Change of Digital Certificate

March 24, 2021

Panasonic i-PRO Sensing Solutions Co., Ltd.

Please be informed that the digital certificate installed in our network cameras and network disk recorders is changed from Digicert certificate to GlobalSign certificate, from April 2021.

Phenomenon due to certificate mismatch and its countermeasure

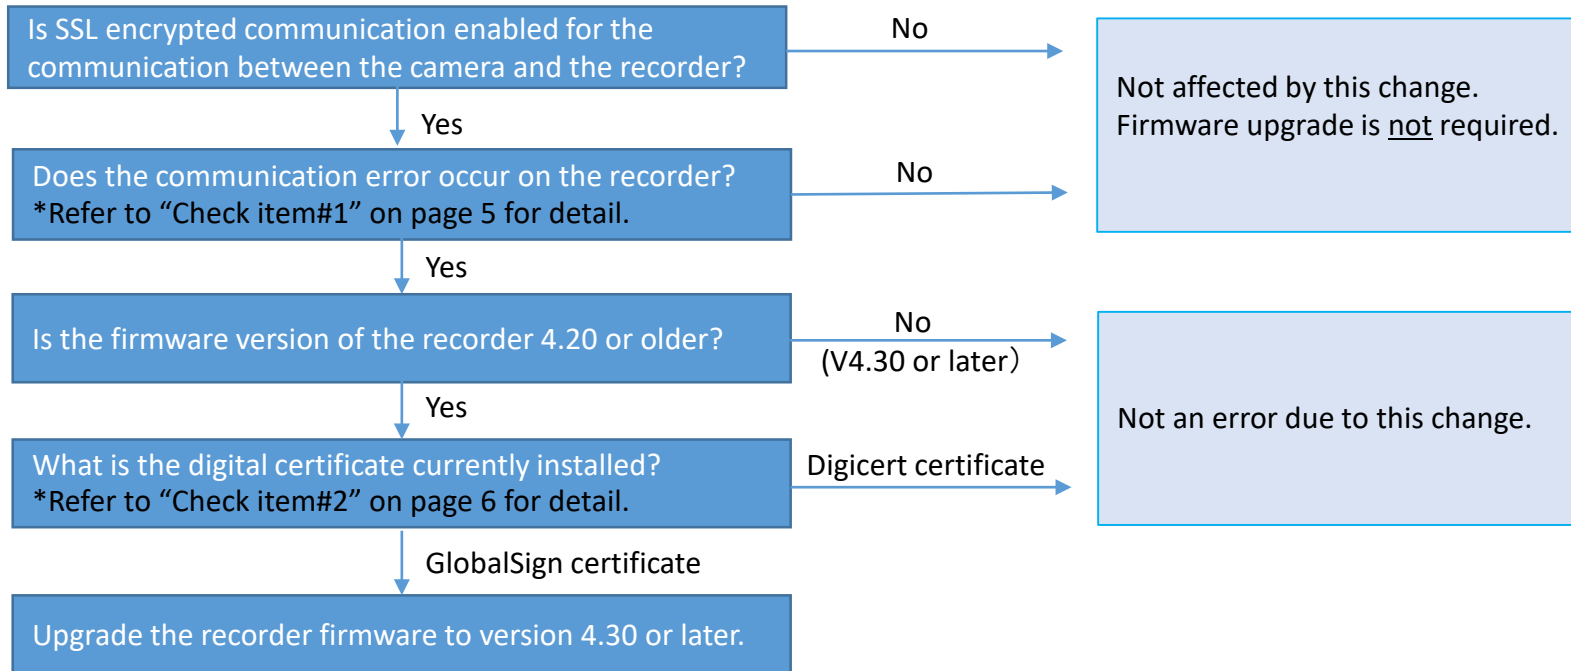
Phenomenon: Communication error occurs on a network disk recorder (*See page 5 for details)

Occurrence condition: When a camera produced in April 2021 or later is connected to a recorder produced in or before March 2021 (version 4.20 or older) in HTTPS (SSL encrypted communication).

Countermeasure: Upgrade the recorder firmware to version 4.30*¹ or later (*¹To be released in the end of March, 2021)

- “Connection error” on the [Camera registration] window

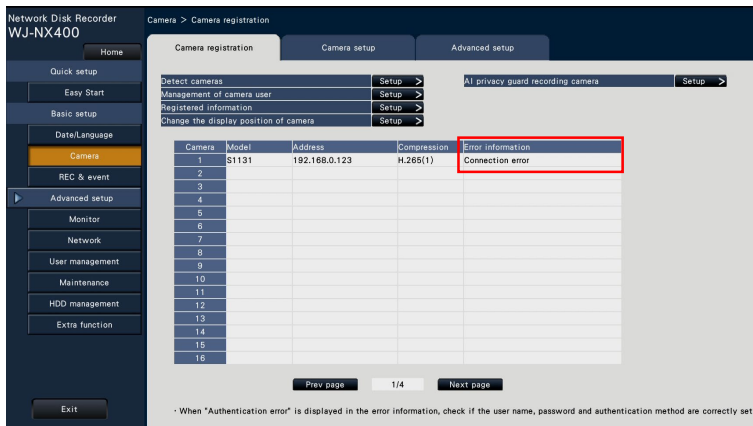
[Camera registration] window under [Basic setup]-> [Camera] shows “Connection error” in [Error information]

- “Communication error” on the status display panel

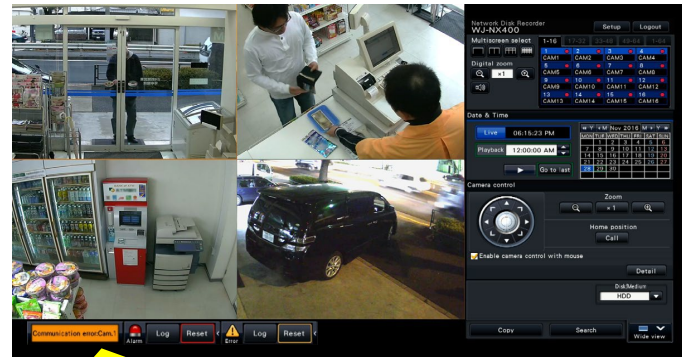
Status display panel on the main monitor shows “Communication error:Cam.xx”.

How to check the digital certificate on the camera browser

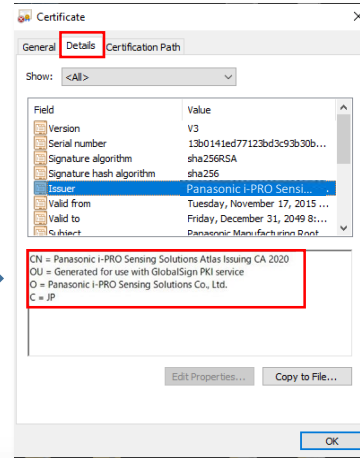
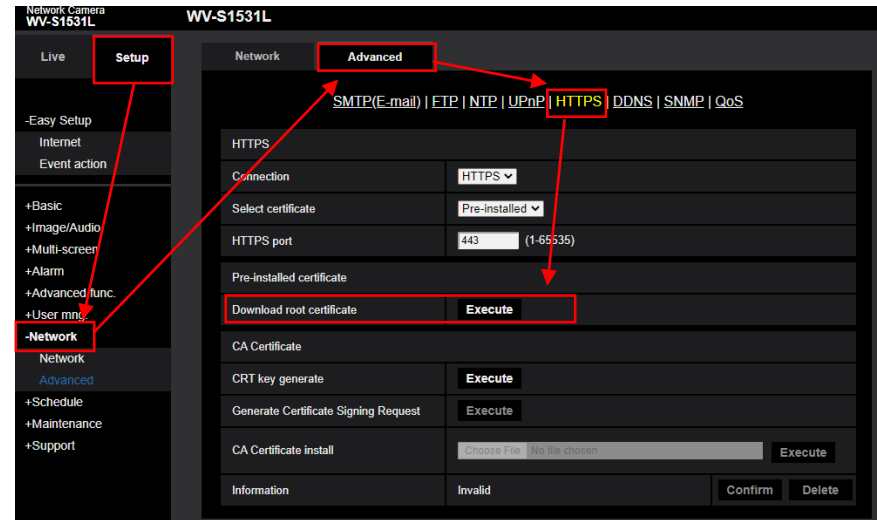
Check the certificate authority as below.

CN = Security System CA:

→ Digicert certificate is installed

CN = Panasonic i-PRO Sensing Solutions Atlas Issuing CA 2020:

→ GlobalSign certificate is installed
